Rezoning Transportation Analysis
Petition Number: Insert Zoning Petition #2021-195
General Location Identifier: 20105108, 20105106

Revision Log:

Date	Description
12-28-2021	First Review (PDM)

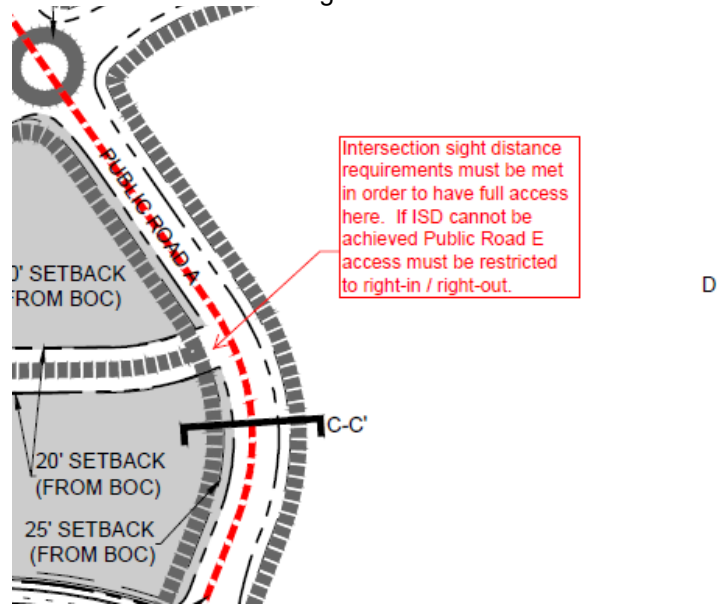
3. Revise site plan and conditional note(s) to commit to construct an 8-foot planting strip, and 12-foot sidewalk on the entire property frontage of Arrowwood Road per Chapter 19 and Chapter 20. The site plan shall label and dimension both items from the back of curb and gutter and road centerline. The 12ft multi-use path also meets the council adopted Charlotte WALKS and Charlotte BIKES policies.

6. **Streetscape, Landscaping and Buffer:**

a. **Arrowwood Road.** A thirty (30) foot setback as measured from the existing back of curb of Arrowwood Road will be provided in Development Area A. A twelve (12) foot sidewalk and minimum eight (8) foot planting strip will be provided along the portions of Arrowwood Road that are being widened because of road improvement requirements. ~~The existing five (5) foot sidewalk is to remain outside of those road widening areas.~~
